STAFF REPORT

RE: Mercy Clinic at Greenway Park

DATE: October 13, 2009

Requested Action Site Plan Approval

Aerial of Project and Surrounding Properties

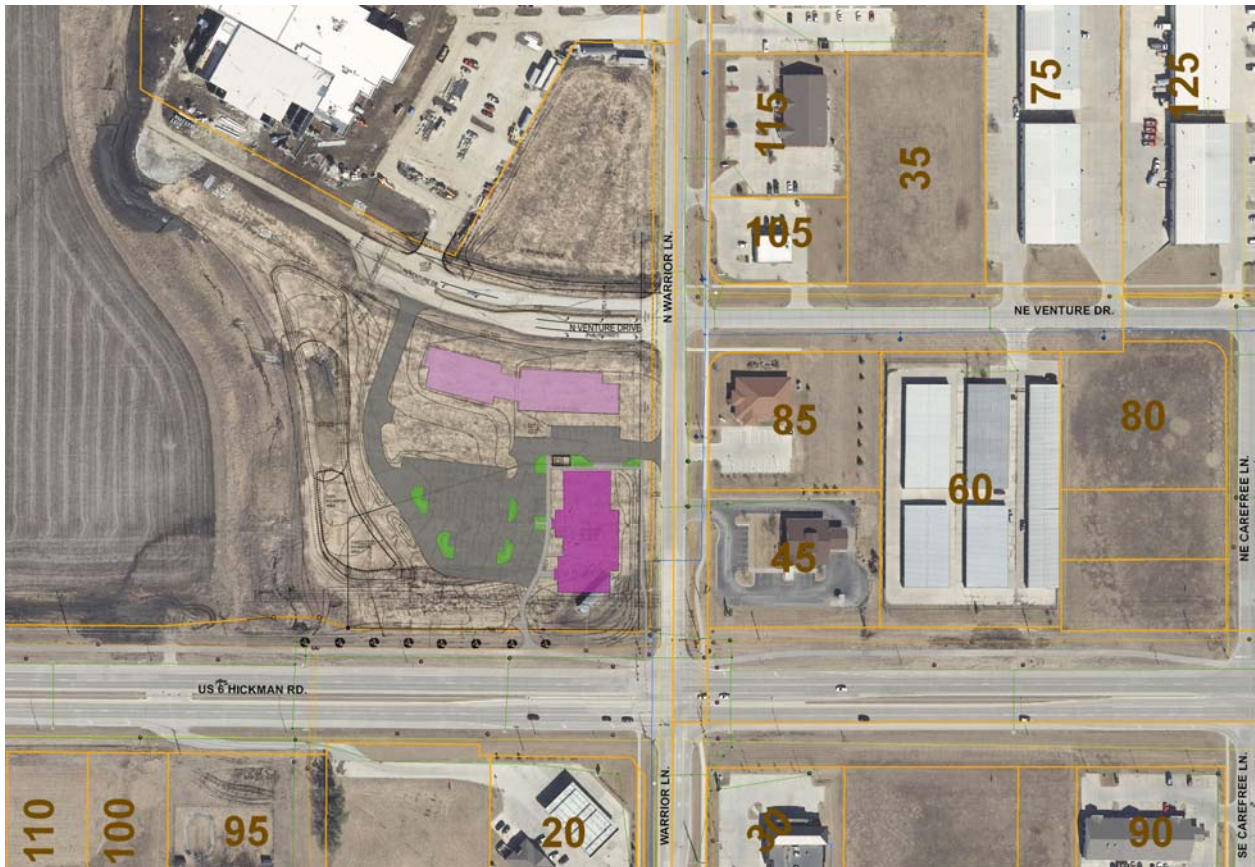
The project is within the overall conceptual development plan proposed by LADCO Development involving the future development of all the Broderick property. At this time the applicant is requesting Approval of a site plan for the development of a medical clinic for Lot 3 of Waukeee Greenway Park Plat I.
